Case Reference No: 11-DR-2019 Trailwest

Stipulations for the Development Review Board Application: Trailwest

WATER & SEWER BASIS OF DESIGN REPORT

DRAINAGE REPORT FOR TRAIL WEST PLAZA

Thank you – Eliana
For reference:
1969 AERIAL

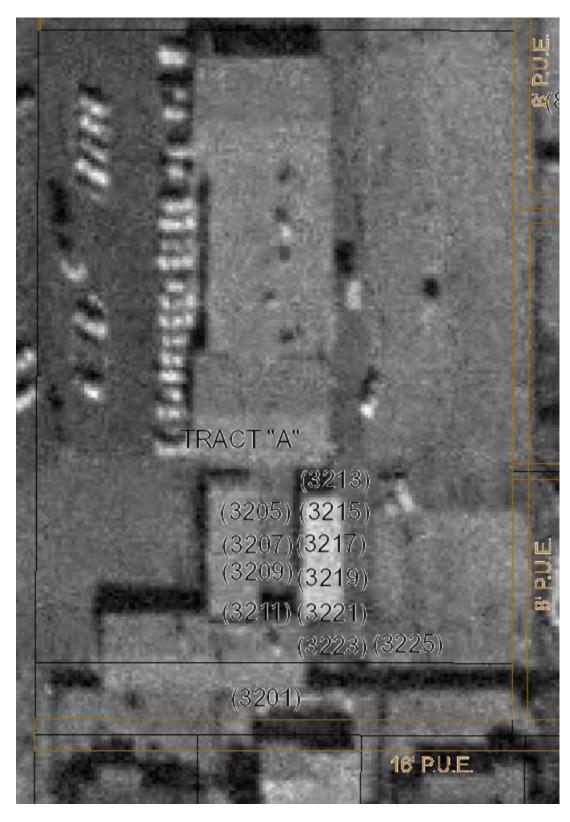
It's clear, based on city's aerial photography that since at least 1969, apn 090-33-085D has shared a parking lot with apn 130-33-085C; apn 130-33-085C being the development project parcel under consideration. As well as apn 090-33-085D's full + exclusive use of the south east quadrant of development property.

The development project is proposing to cut off the adjacent parcel from a shared and open parking lot which today provides adequate circulation into and out of adjacent parcel for visitors, employees etc + refuse service (prescriptive right) as well as denying the adjacent parcels ownership of southeast quadrant of development parcel (adverse possession). Proposed development will create an unsafe circulation situation for adjacent parcel and the city of

Scottsdale's traveling public along Hayden as well as solid waste services (solid waste will now be required to provide refuse service to adjacent parcel from Hayden, a city major arterial at this location with a posted speed limit of 45 mph).

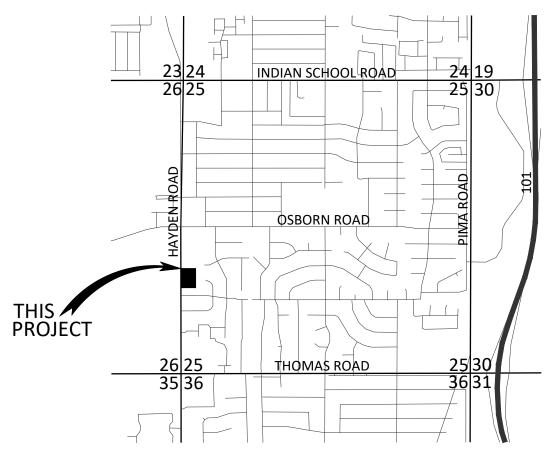
The Project's anticipated drainage fixture unit count is 186 and is designed with an anticipated 6-inch existing sewer laterals with an assumed minimum slope of 2.0%. Per the International Plumbing Code, Table 710.1(1), the maximum DFU based on the above parameters is 840. If it is found to be a 4-inch existing sewer line with an assumed minimum slope of 2.0%, the maximum DFU is 216; thus the expected maximum 186 DFU is acceptable if the sewer laterals are found to be either 4" or 6" diameter.

6" minimum
